ARCHITECTURAL REVIEW BOARD STAFF REPORT

Project #/Name	CCP-2019-02: Regional P25 Radio Infrastructure Project
Review Type	Advisory Review
Parcel Identification	076000000054P0, -54P1, - 54N1, and -54Z0
Location	County Office Building, 5 th Street (COB5) – 1600 5 th Street (Figure 1)
Zoned	Commercial Office (CO)/Entrance Corridor (EC)
Owner/Applicant	County of Albemarle/Harris Corporation (Helen Moeller)
Magisterial District	Scottsville
Proposal	Establish a microwave radio communications facility supporting operations of the Charlottesville-UVA-Albemarle County Emergency Communications Center (ECC) at its COB5 backup dispatch and equipment facility. See “Project Details” and Attachment A for additional information.
Context	The subject parcel lies on the south side of 5 th Street. Stagecoach Road is nearby on the east, south and west. Single family residences are on both sides of Stagecoach Road. Residential apartment complexes and Region Ten offices are located on the opposite side of 5 th Street. A mix of residential types are in the general area. (Figure 1)

Figure 2: Illustration showing the proposed monopole and dish antennas.

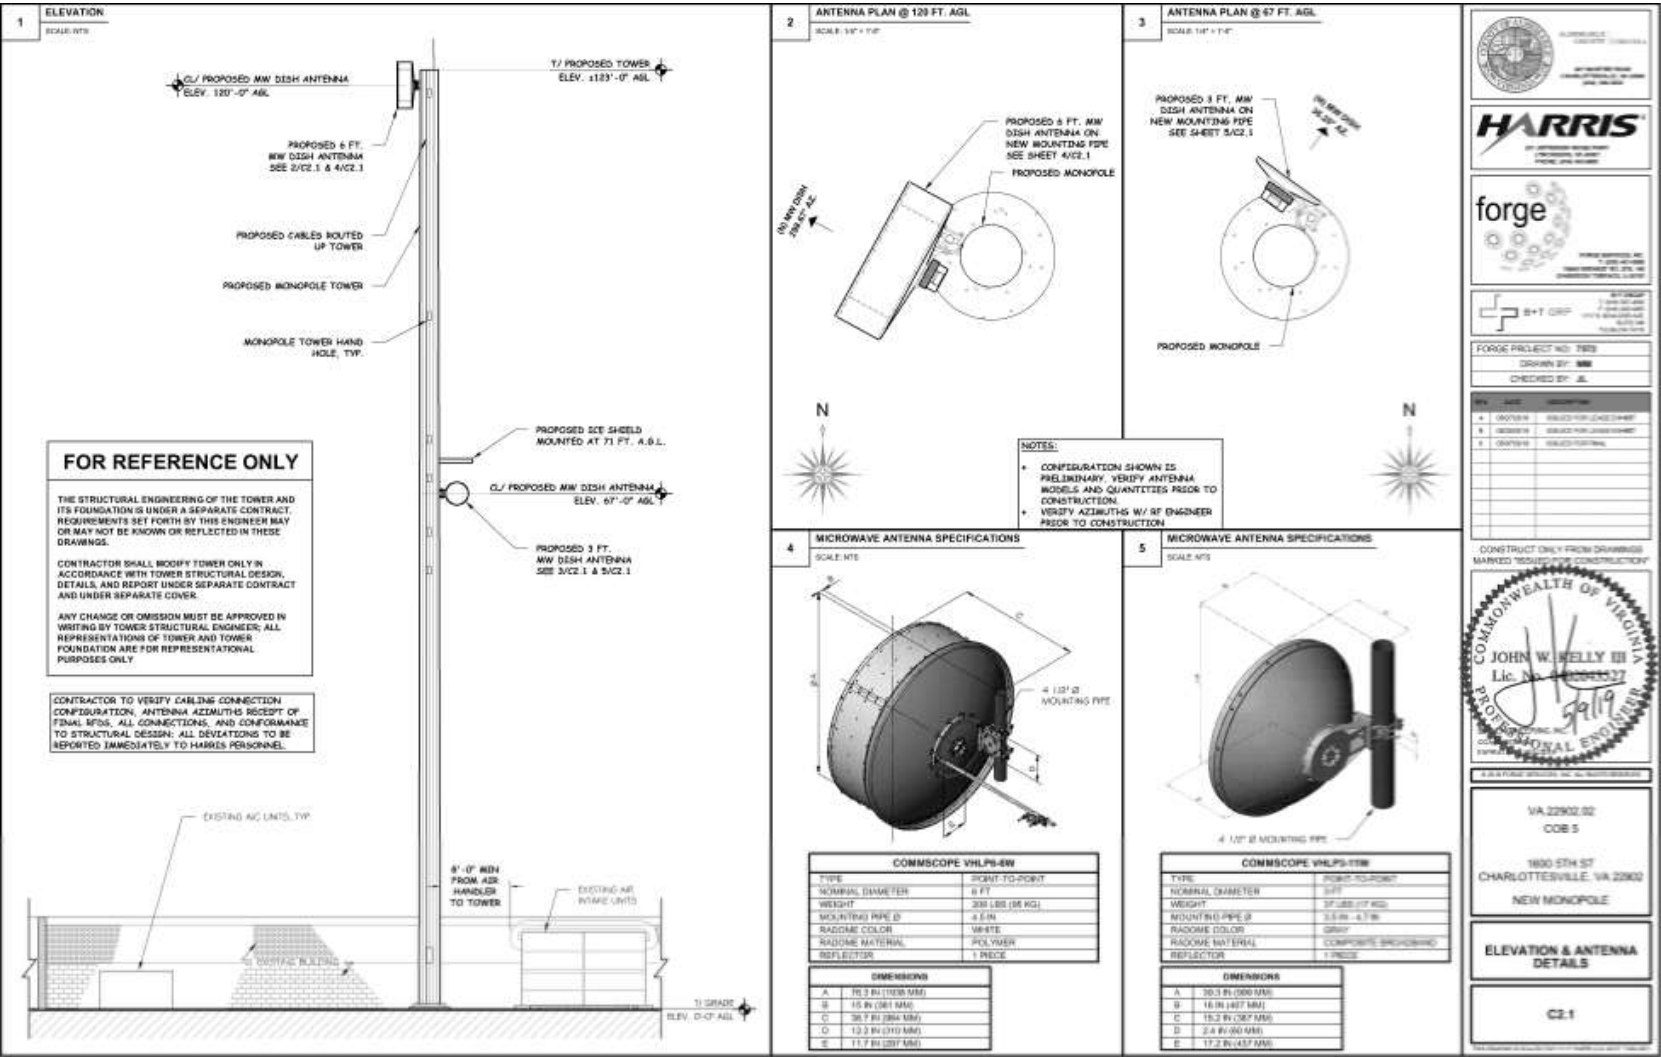
The proposal includes a 123'-tall monopole with two microwave dish antennas, a 6' antenna mounted at 120' AGL and a 3' antenna at 67' AGL. An ice shield is proposed at 71' AGL. Related ground equipment is also proposed. The facility is proposed to be located within the existing mostly enclosed parking and equipment area at the rear of the office building. (Figures 2 and 3)

1. Given the degree of visibility displayed at the balloon test, the proposed location of the facility does not sufficiently minimize the visibility of the monopole from the 5th Street and I-64 Entrance Corridors. Negative visual impact is anticipated.
2. A shade of light grey is recommended for the monopole.

Figures 3a, b and c: The facility is proposed to be located within the mostly enclosed parking and equipment area at the rear of the COB5 office building.

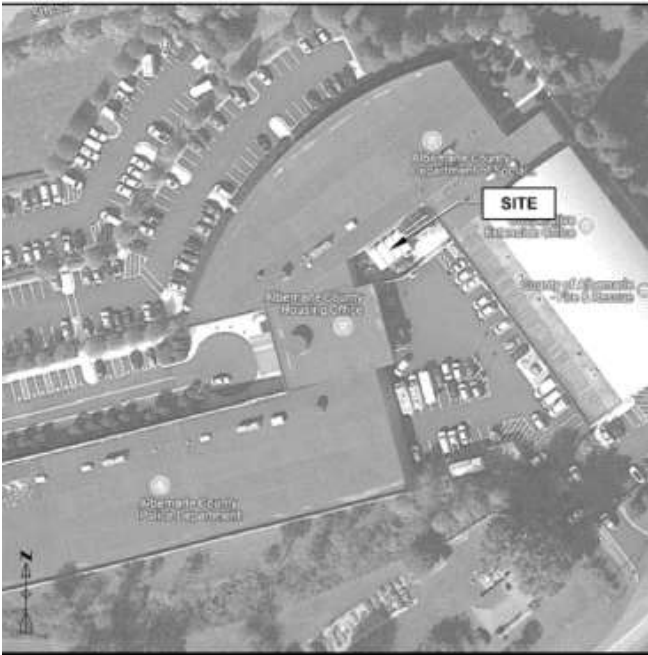
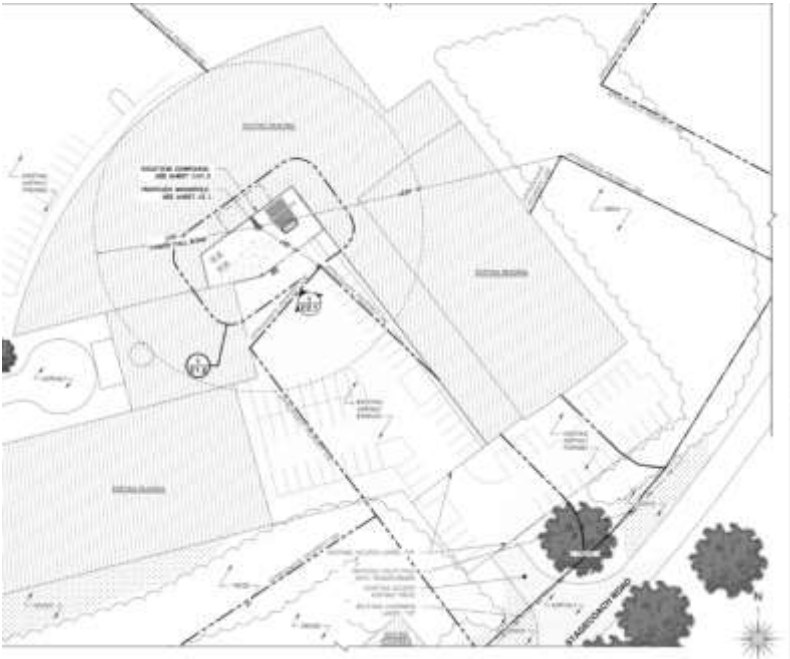
Ref	Guideline	Issues	Recommendations
	Accessory structures and equipment		
17	The following should be screened to eliminate visibility from the Entrance Corridor street: e) Mechanical equipment.	The ground equipment is not expected to be visible from the 5 th Street Entrance Corridor because the office building will provide full screening. (Figure 3)	No objection.

Since the ground equipment will not be visible from the EC, the ARB has no objection to the ground equipment and base station as proposed.
